project
Black Country Retrofit Wrap and Associated Works
100 - 122 Darlaston Road, Kings Hill, WS10 7SR

title
Window Jamb Detail

job	dwg no	rev	date	date
18-1540	509	A	scale drawn	Jul 20 1:5 @ A3 RP

Window Jamb Detail Cementitious Cladding (Scale 1:5)

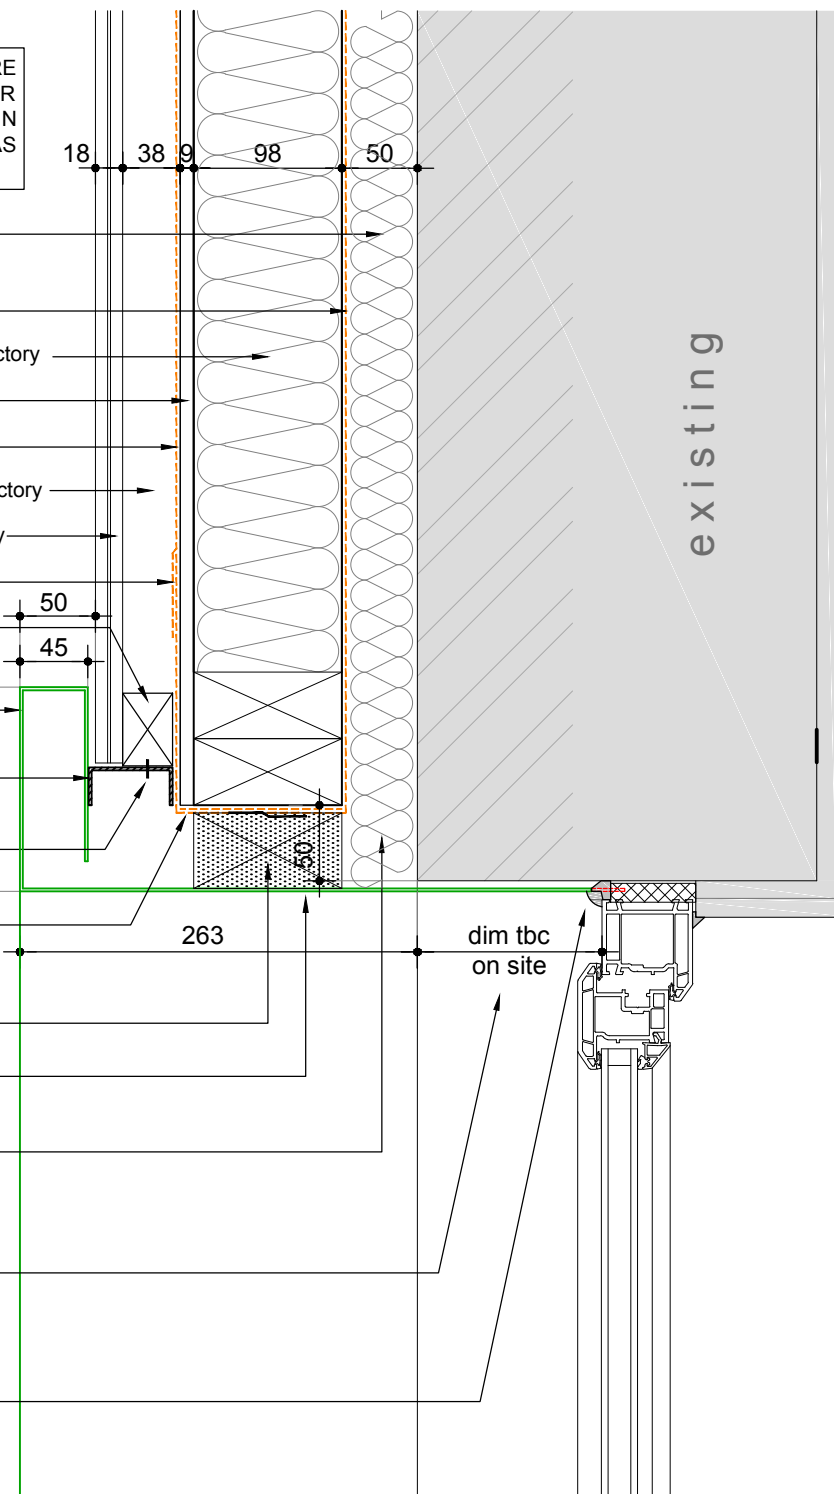
A Aluminium profile revised and insulation added to external face of existing wall. Dwg no. revised 22/08/20 RP
